License and Variance Board Meeting - Final

D. **V24-090** Public Hearing - Variance Request - V24-090 - Allow encroachment into the City's 50-foot undisturbed buffer - Land Lot 416 - 2805 Eastfield Road - Joshua Oliver

RE: VARIANCE CASE V24-090
2805 Eastfield Road – Allow encroachment into the City’s 50-foot undisturbed buffer

Figure - 2
Site Plan

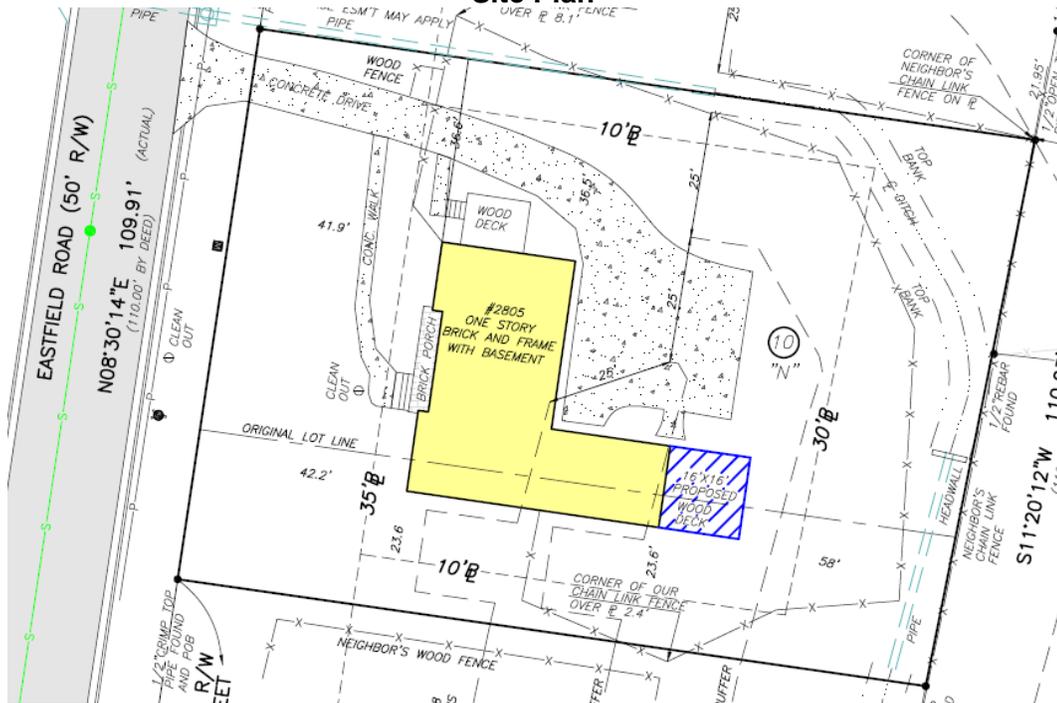
The applicant is proposing to replace an existing 256 square foot deck in its current location. The rear yard and a portion of the home itself is greatly encumbered by the State’s 25-foot undisturbed buffer, the City’s 50-foot undisturbed stream buffer, and the City’s 75-foot impervious surface setback, with no section of the rear yard untouched by stream buffers. Since the property was platted in 1954, prior to the Stream Buffer Protection Ordinance in 2005, the hardship is not self-created. No other variances are needed as the property is below their impervious coverage maximum of 35% and the deck is well outside the setbacks.

The applicant will require relief from the City’s stream buffer ordinance in order to make the improvements in the rear yard. The applicant will mitigate the rear yard disturbance by extending the 50-foot undisturbed buffer into the 75-foot impervious surface setback and then extending the 75-foot impervious surface setback on the south side of the home to offset the

256 square foot encroachment. The new impervious area will be contiguous with the existing setback area and will require an update to and recording of the parcel plat to delineate the new undisturbed and impervious setback limits. The City Engineer has reviewed the application and accompanying mitigation plan and supports the method used for buffer mitigation per the Georgia Stormwater Management Manual requirements.

1. Approval of the requested variance shall be conditioned upon substantial compliance with the mitigation plan submitted with the variance application.
2. A plat shall be submitted to the City for approval and subsequently recorded with the Cobb County Superior Court to show the extension of the undisturbed buffer and impervious surface setback prior to issuance of the building permit.
